PLANNING COMMITTEE SOUTH - UPDATE SHEET

20 DECEMBER 2022

Item 6 – DC/22/0998/FUL – Residential development of 32 dwellings, together with areas of new public open space and the provision of a new access to the site from the B1077 on land east of Mow Hill/B1077, Witnesham, IP6 9EH

- 004 E Proposed Layout
- 005 E External Works Layout
- 007 A Street Scene

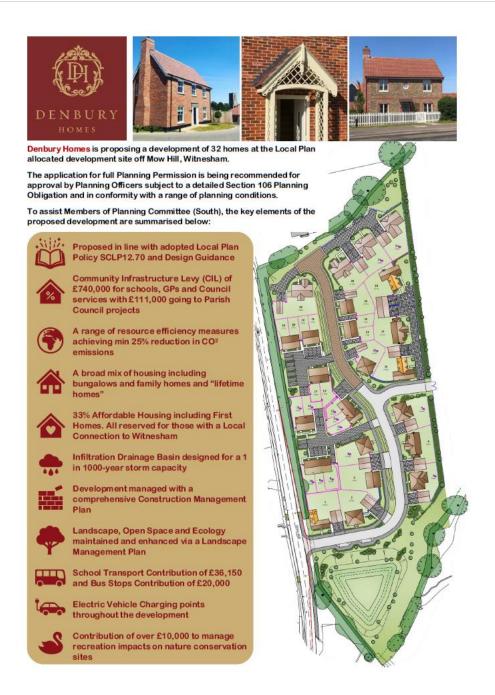
Revised Plans were received on 14 December 2022 which sought to overcome matters raised within the officers report:

- A reduction in the amount of footway around the agricultural access adjacent to plot 7 as requested by the Landscape Officer. This allows for a less engineered and softer approach to the field boundary. There is a crossing point so there is a continuous footway for pedestrian connectivity within the site.
- The area to the south of the basin is shown as part of the development site; the post and rail fence has been removed on the boundary. This is also shown on the external works layout.
- Updated housing mix which integrates First Homes into the affordable housing mix. Of the ten affordable units the mix will comprise of:
 3 no. First Homes (plots 8, 9 and 10), 5 no. affordable rent (plots 11, 12, 13, 14 and 15) and 2 no. shared ownership (plots 16 and 17). A commuted sum will also be provided for the additional percentage of an affordable unit, as set out in the Committee report.
